**CITY OF SAINT PAUL
HERITAGE PRESERVATION COMMISSION STAFF REPORT**

FILE NAME: 962 Summit Avenue
DATE OF APPLICATION: April 1, 2020
APPLICANT: John Sharkey, Sharkey Design Build
DATE OF HPC MEETING: April 20, 2020
HPC SITE/DISTRICT: Historic Hill Heritage Preservation District
LEGAL DESCRIPTION: Lot 10 and the east 20 feet of Lot 11, Block 27, Summit Park Addition to St. Paul
NRHP: Historic Hill District
SRHP: Historic Hill District
CLASSIFICATION: New Construction
ZONING: R2 **WARD:** 2 **PLANNING DISTRICT:** 16 – Summit Hill Association
STAFF INVESTIGATION AND REPORT: Christine Boulware
DATE: April 13, 2020

Memorializing the Saint Paul Heritage Preservation Commission's April 20, 2020 decision approving the construction of a new, single-family residence with and attached three-stall garage on the vacant lot at 962 Summit Avenue.

① Left Elevation
1/4" = 1'-0"

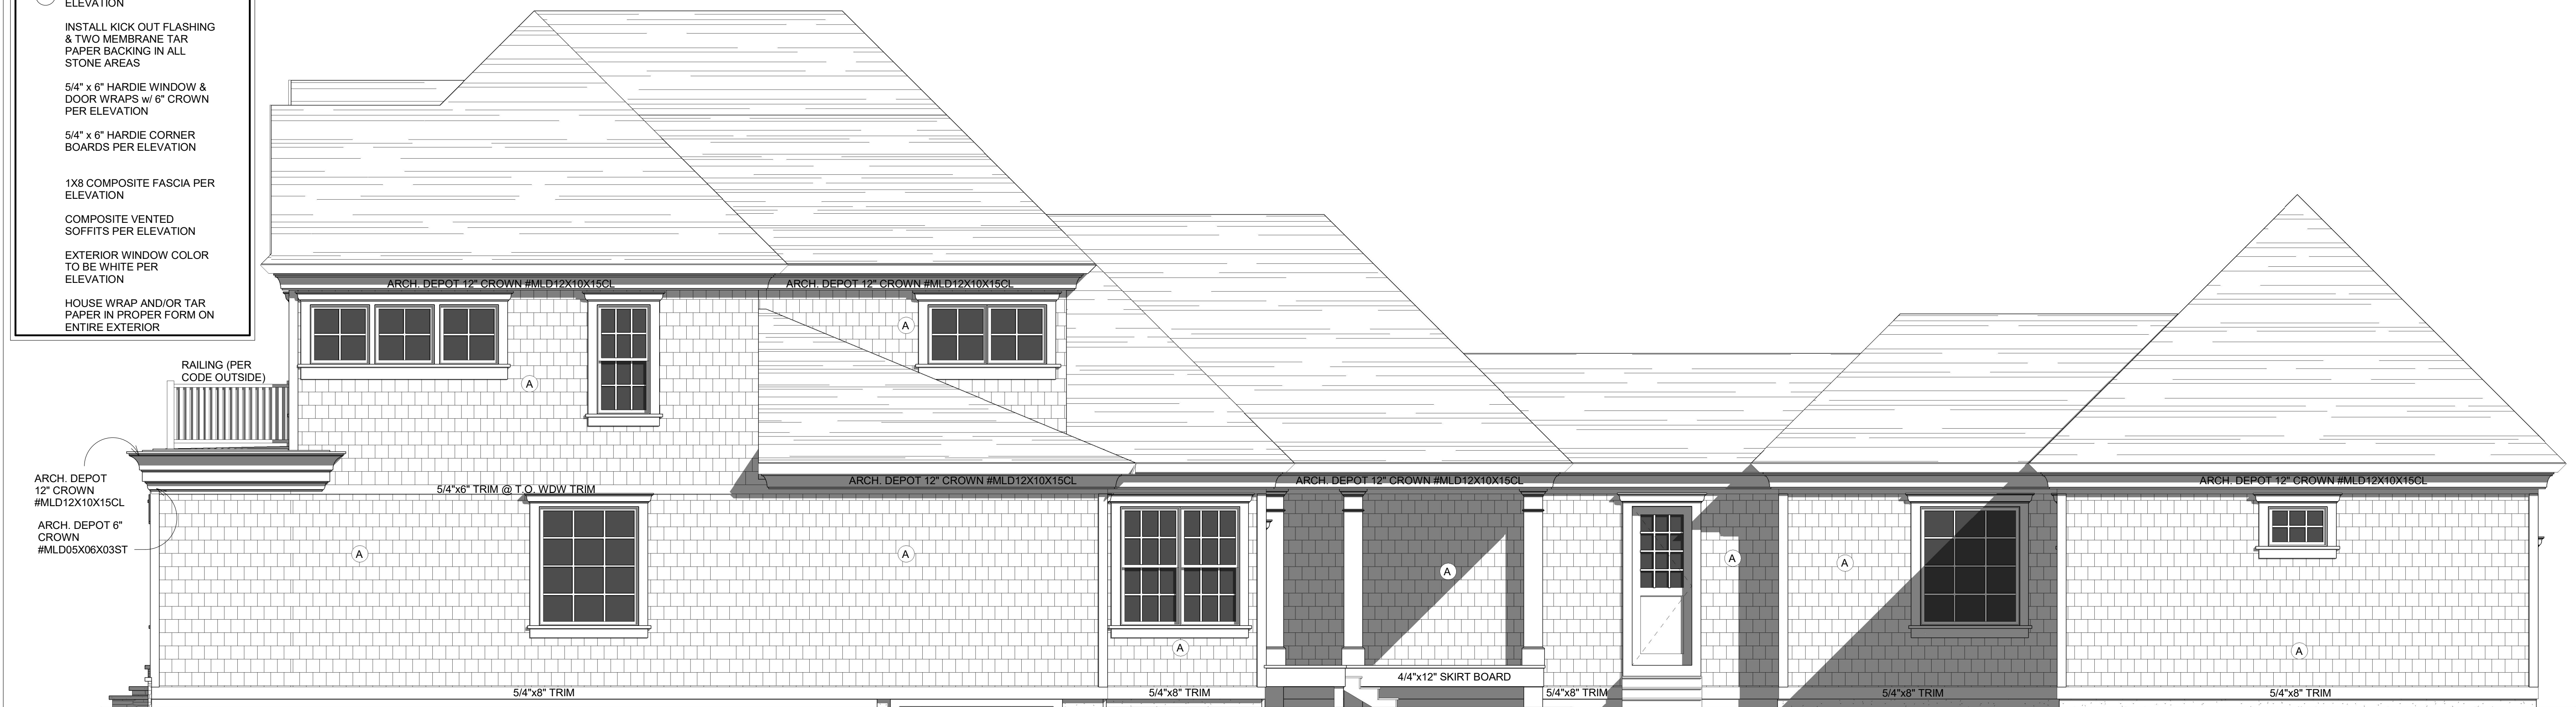
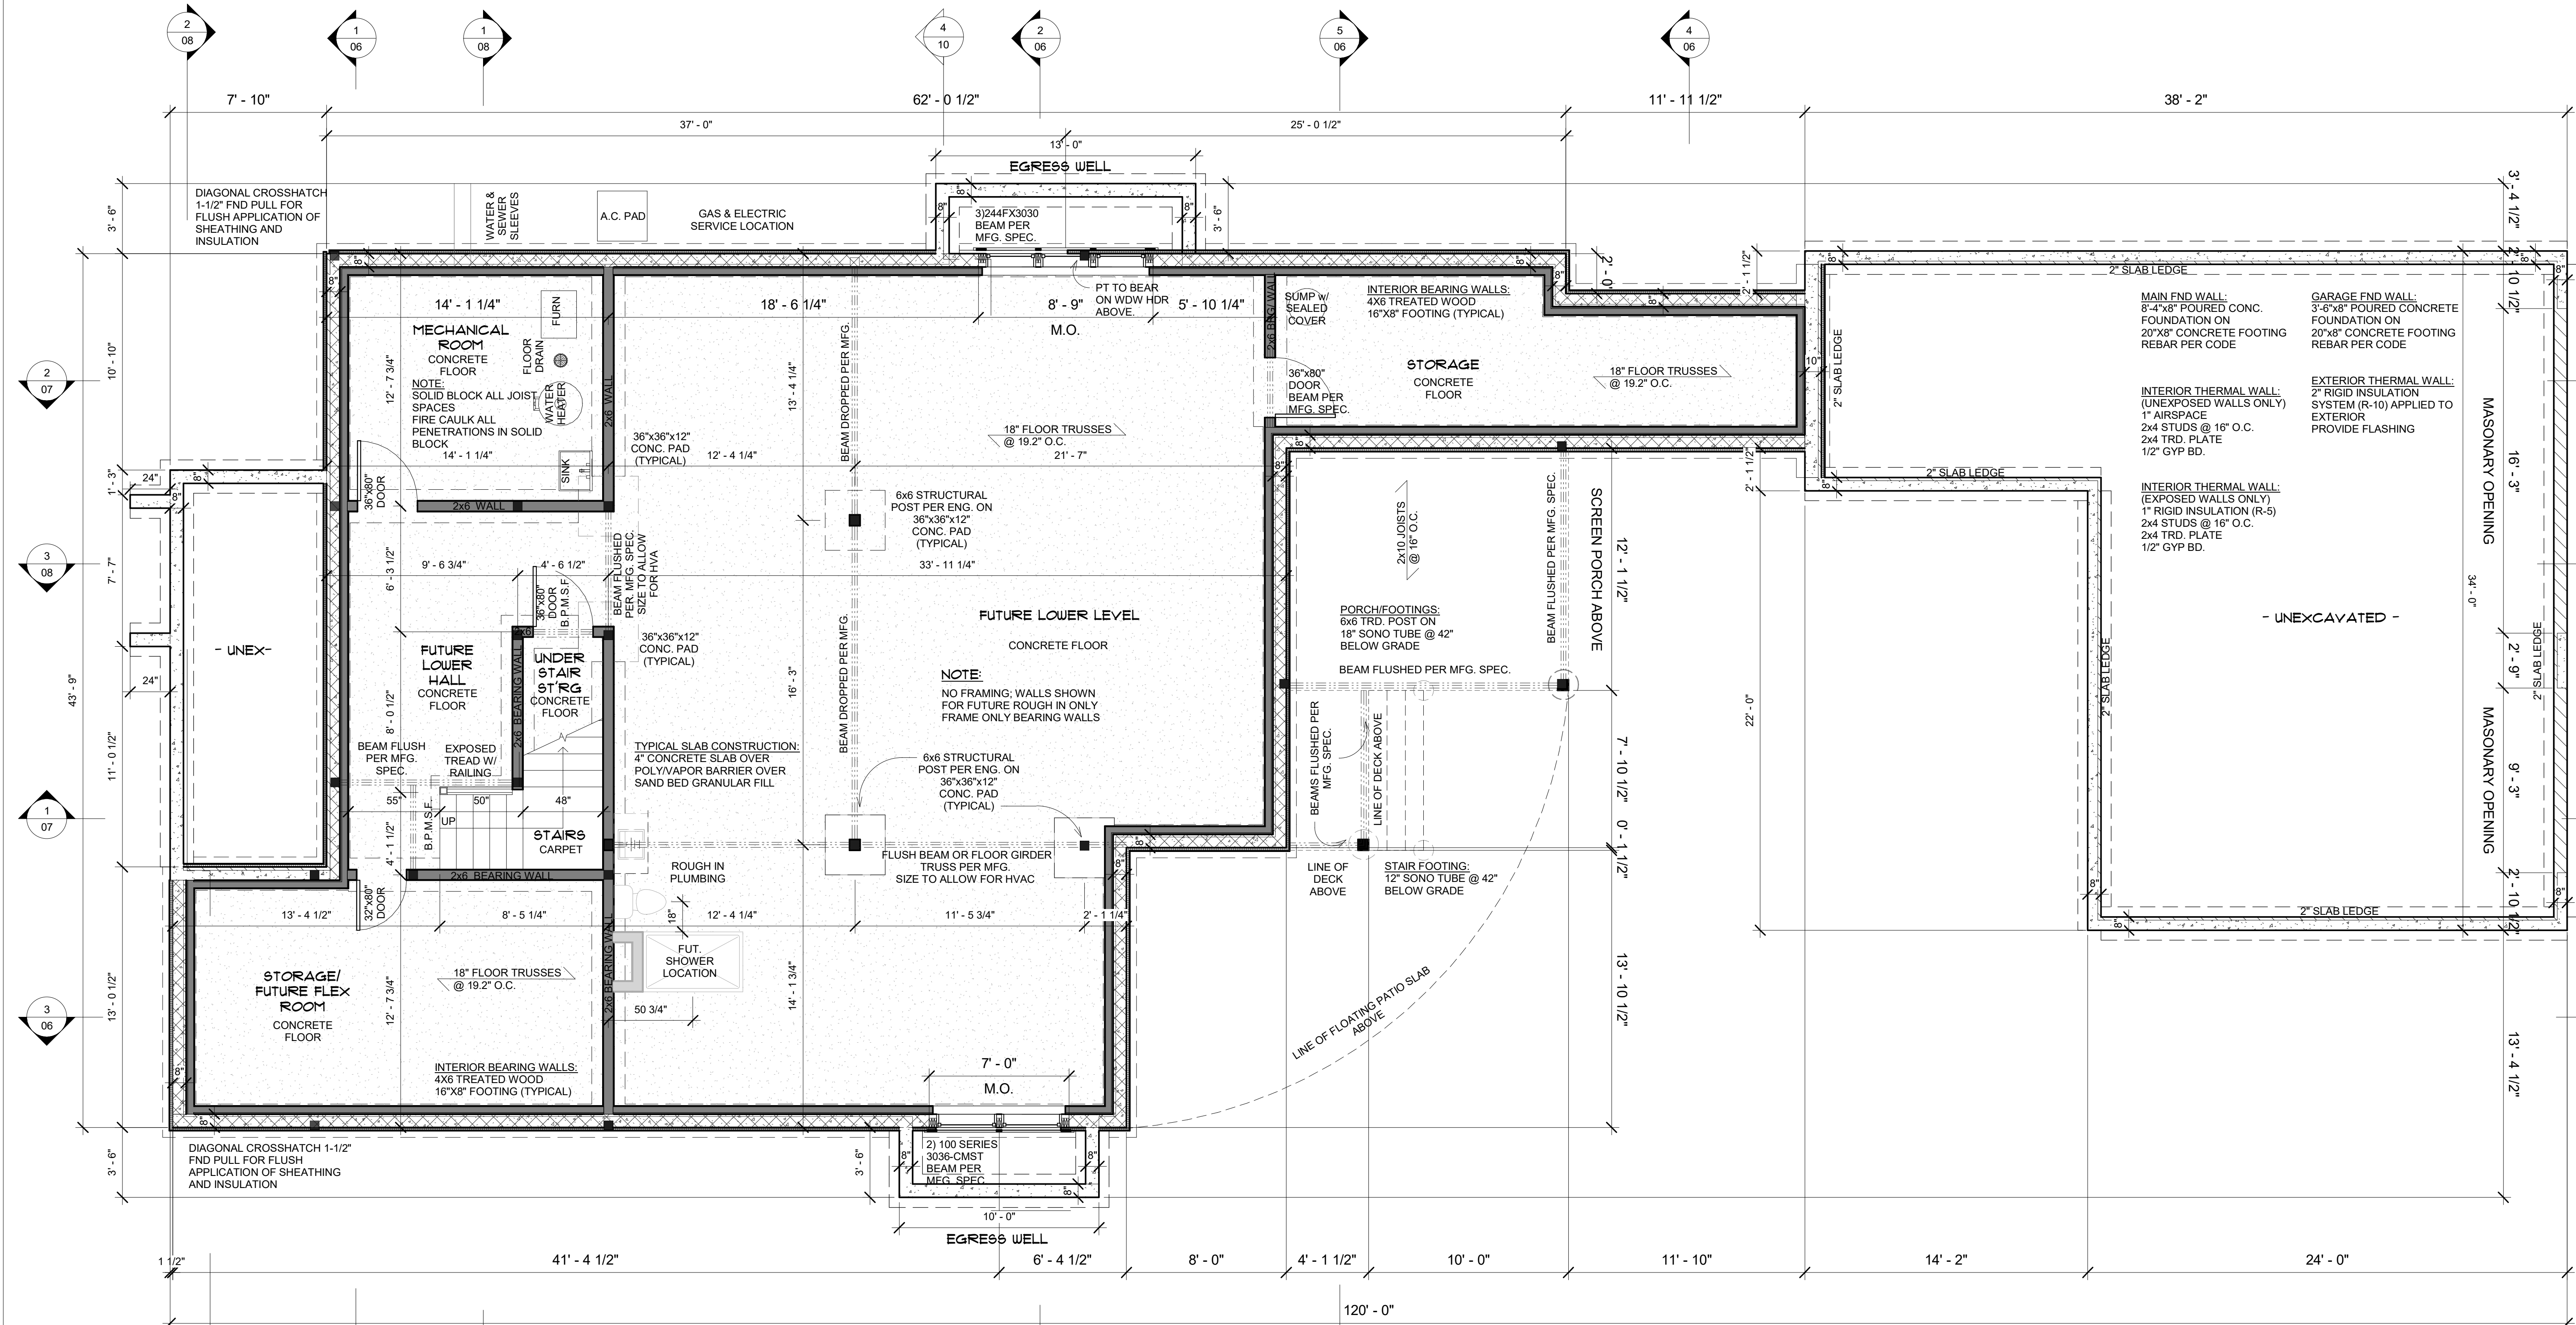
3. Materials – final material specifications/drawings/finishes will need to be included with the f
 - a. At the meeting you indicated that the Hardie Shake Shingles will have a smooth texture (not woodgrain)

- b. At the meeting you indicated that the Andersen windows will have muntins with profiles (not just grilles-between-glass)
 - c. At the meeting the HPC discussed the need to address the size, scale, material, color or the foundation. Please contact staff to discuss options. Look to other foundation materials along the block for treatment options.

- d. Staff advised that the windows should have historically appropriate proportions and the vinyl-clad sash exteriors should have a dark finish.
 - e. A final materials/finishes board shall be prepared and submitted for HPC review.

1. All siding, shingle-shingle siding, and trim shall have a smooth texture
2. Window muntins shall have both interior and exterior profiles.
3. Foundation materials, details, colors and finishes will require final review and approval by a design review committee of the HPC.

CERTIFICATE OF SURVEY

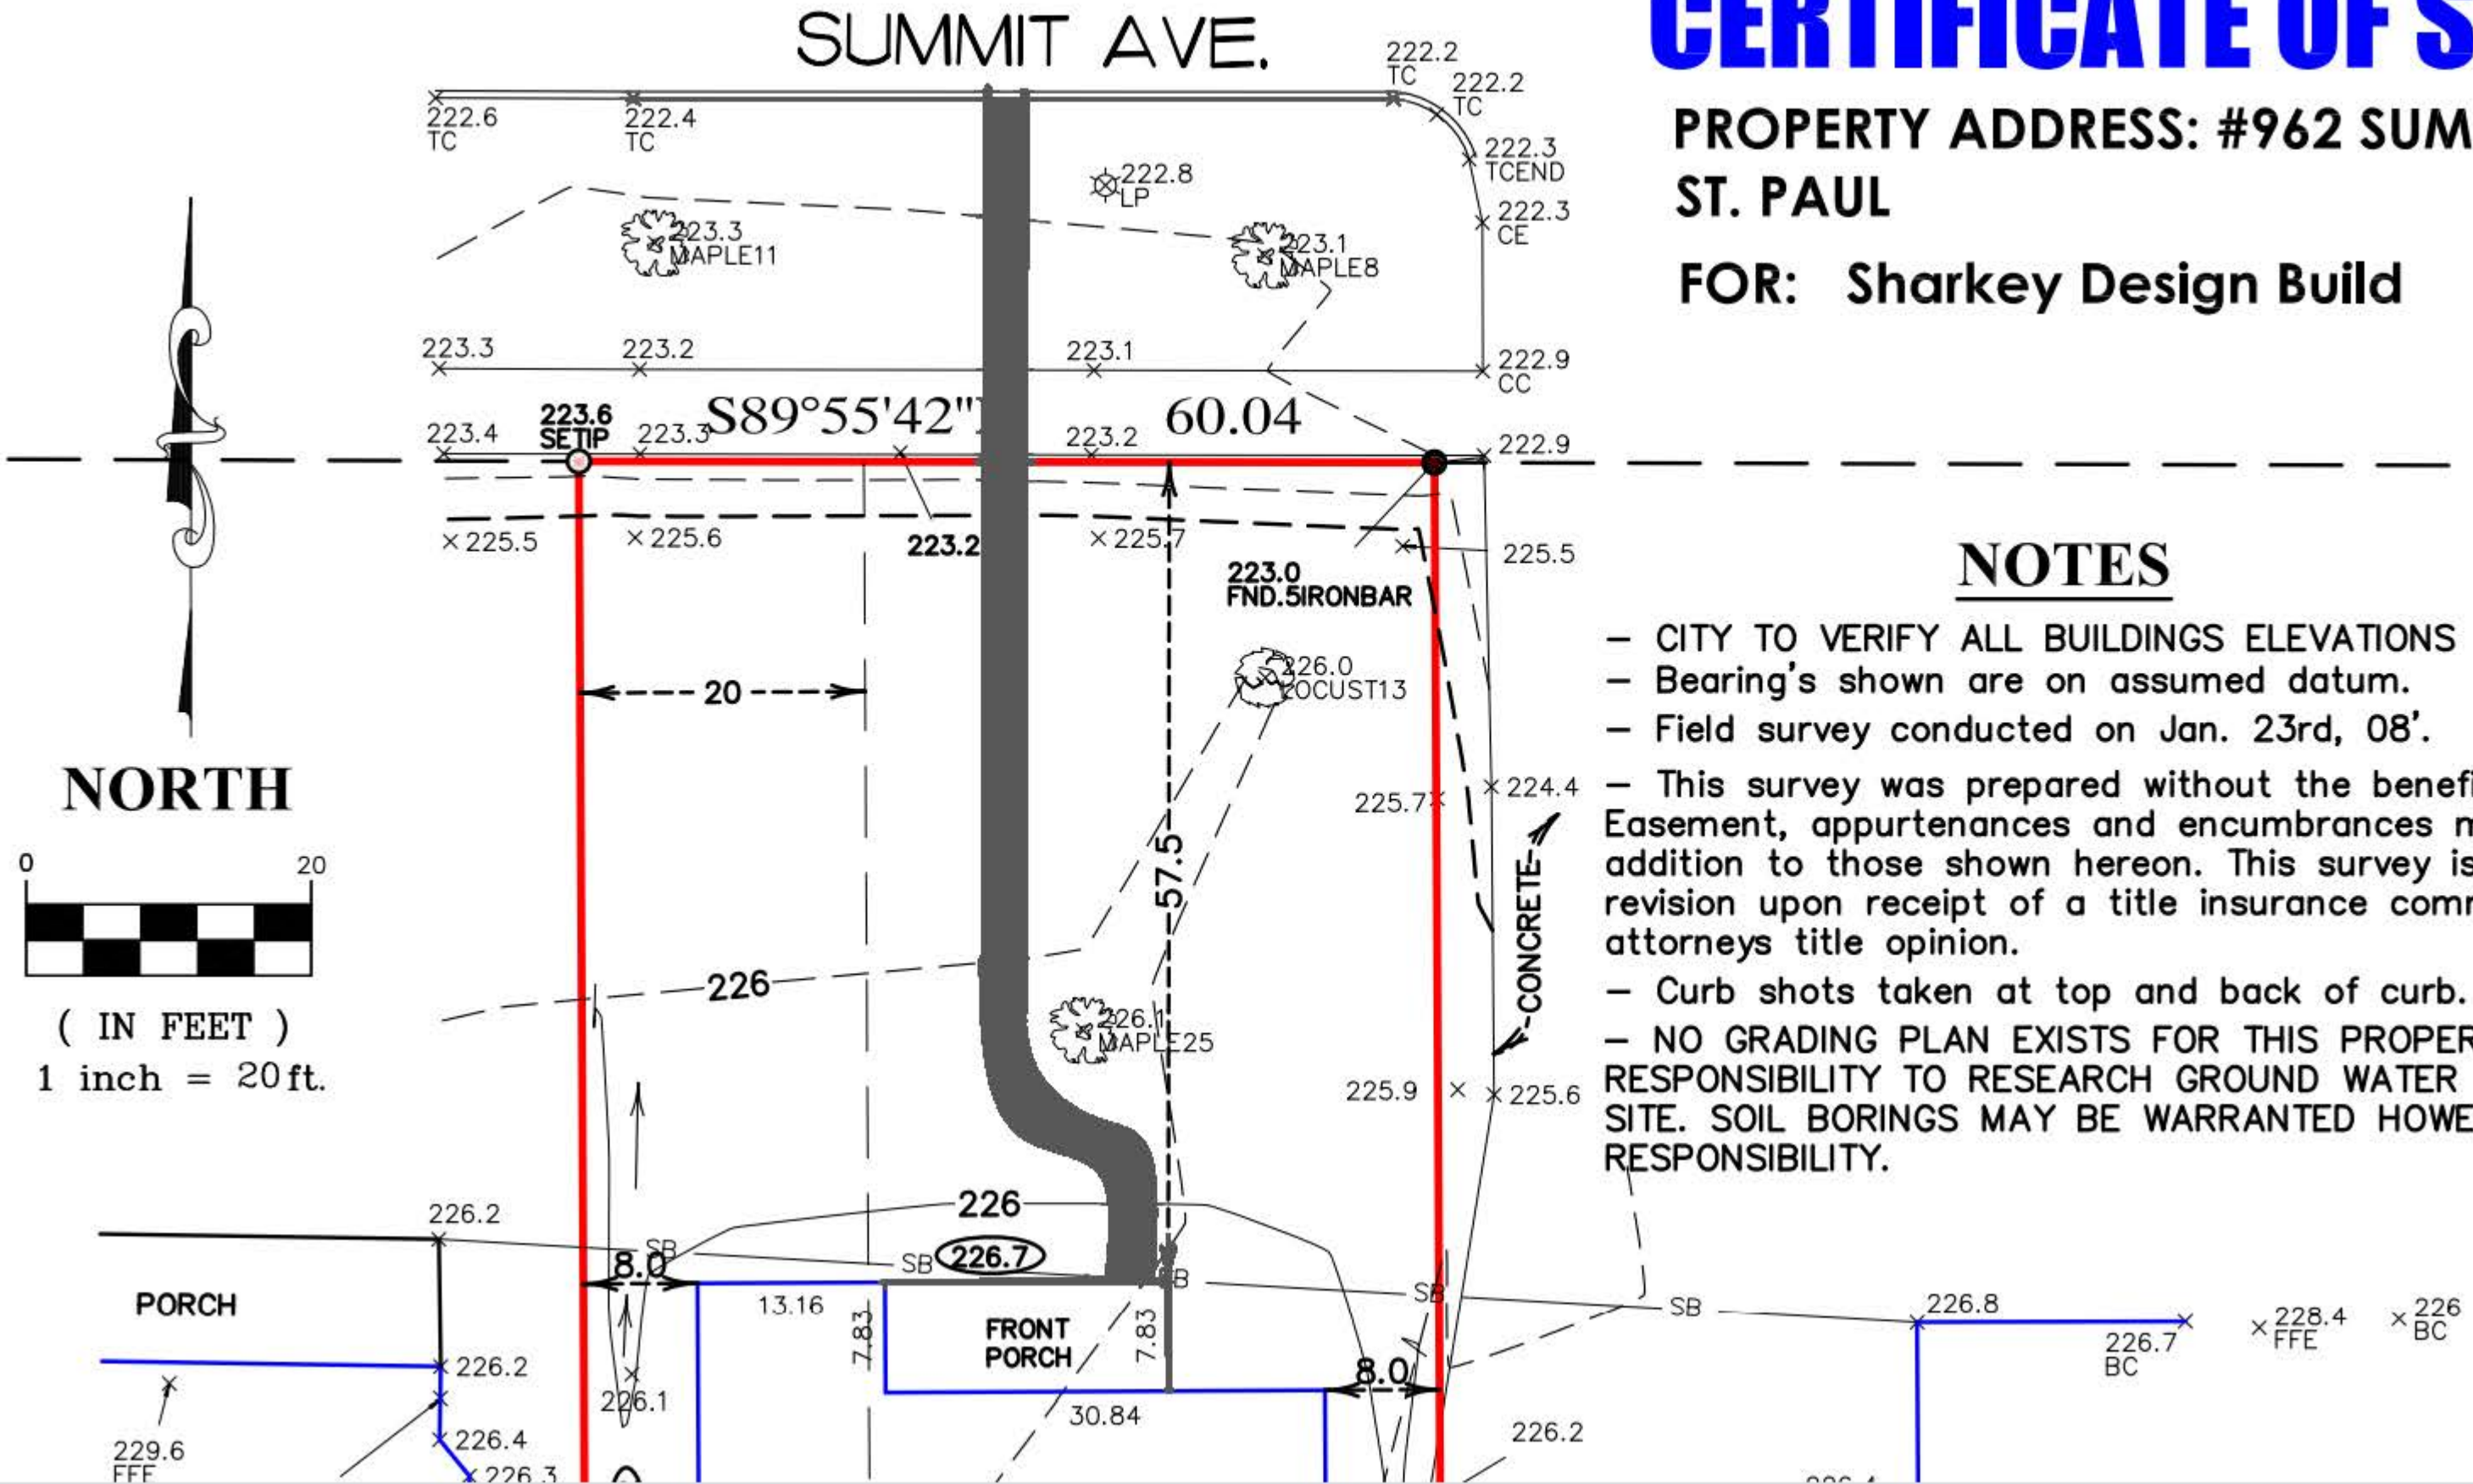
1. Provide scaled elevations of the adjacent residences next to the new construction so that staff and the HPC can review and determine if the size, scale, massing, height and rhythm of the new construction is compatible with the surround structures.
2. The setback concerns were addressed in the revised survey that was submitted to staff. The HPC did not provide additional comments on the revised survey.
